Access Compliance Report

Public Rights-of-Way

(Curb Ramps)

Intersection ID: N/A	Main Street: TWITTER_LN	Cross Street: ROCKY_RIVER_RD	Location: NE
ADA ID: 575D2542EDB9	Ramp Type: Para	Initial Pass/Fail: Fail	Overall Compliance: No
Codes/Mitigation Info/Possible Solution		Field Measurements/Component Compliance

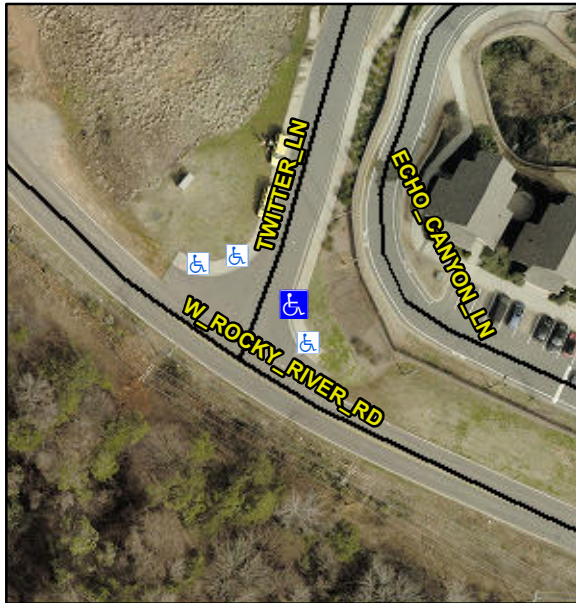
R304.5.3, R304.3.2

Compliance	Description	Data	Compliance	Description	Data
N/A	Ramp Length LT (in)	57.0	N/A	Ramp Length RT (in)	55.0
Yes	Ramp Width LT (in)	59.0	Yes	Ramp Width RT (in)	60.0
Yes	Ramp Slope LT (%)	5.9	No	Ramp Slope RT (%)	9.1
No	Ramp XSlope LT (%)	2.4	Yes	Ramp XSlope RT (%)	1.2
N/A	Landing Length (in)	N/A	N/A	DWS Provided?	N/A
N/A	Landing Width (in)	N/A	N/A	DWS Contrast?	N/A
N/A	Landing Slope (%)	N/A	N/A	DWS Length (in)	N/A
N/A	Landing X Slope (%)	N/A	N/A	DWS Full Width?	N/A
N/A	Landing Curb? (Y/N)	N/A	N/A	DWS Offset (in)	N/A
N/A	Shared Landing?	N/A			
N/A	Gutter Ponding?	N/A	N/A	Gutter Slope (%)	N/A
N/A	Gutter Lip Ht (in)	N/A	N/A	Gutter X Slope (%)	N/A
N/A	Painted X Walk1?	No	N/A	Painted X Walk2?	N/A
	X Walk 1 Direction	To W		X Walk 2 Direction	N/A
N/A	X Walk 1 Width (in)	N/A	N/A	X Walk 2 Width (in)	N/A
	X Walk 1 Slope (%)	3.0		X Walk 2 Slope (%)	N/A
	X Walk 1 X Slope (%)	1.6		X Walk 2 X Slope (%)	N/A
N/A	Ramp inside XWalk1?	N/A	N/A	Ramp inside XWalk2?	N/A

Remove & Replace Entire Ramp.
